DATE: February 17, 2026
PROJECT: Harrison Township District 10
Sheriff Substation Renovation

PROJECT ADDRESS: 6001 N. Dixie Drive, Dayton, OH 45414

ADDENDUM NO. 2

SHEET NO.
S1.0

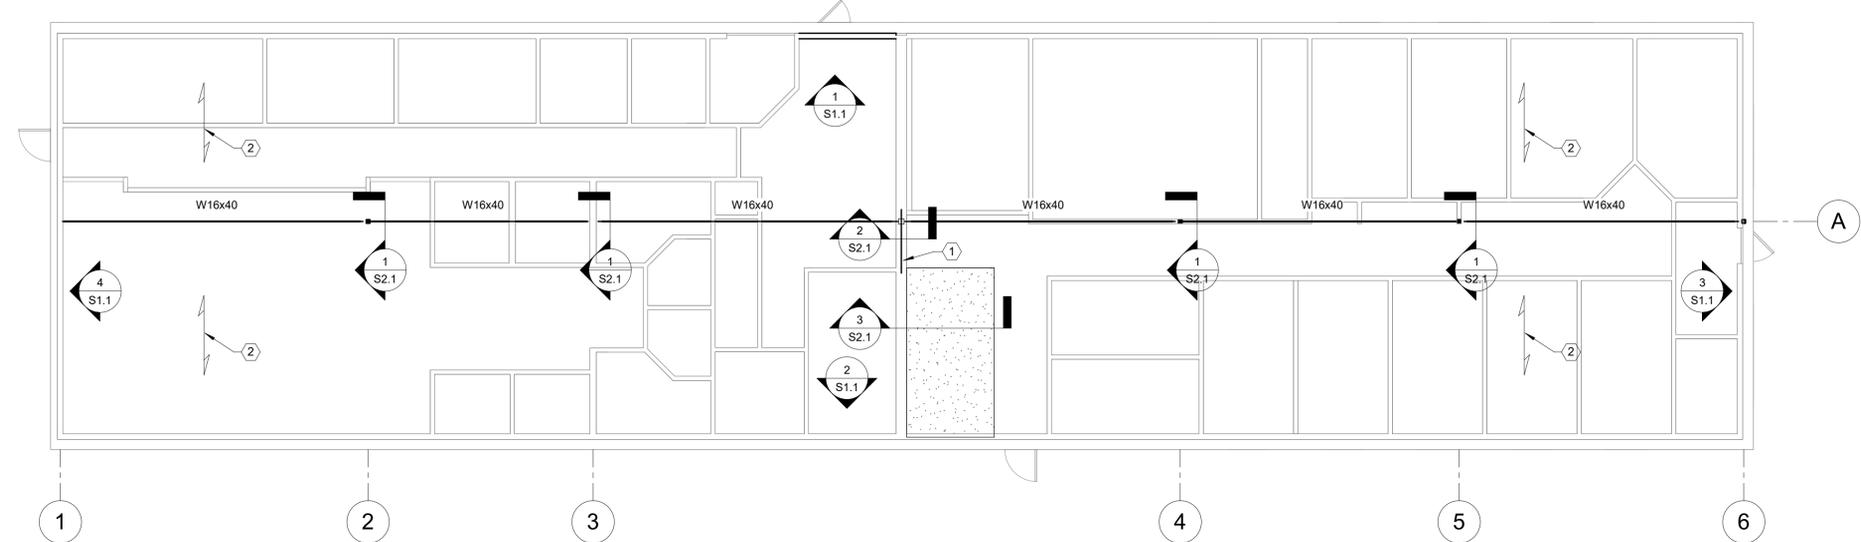
ITEM S1 STRUCTURAL DRAWING SHEET NO. S1.0
DELETE Detail 7/S2.0 at north and east entry doors.
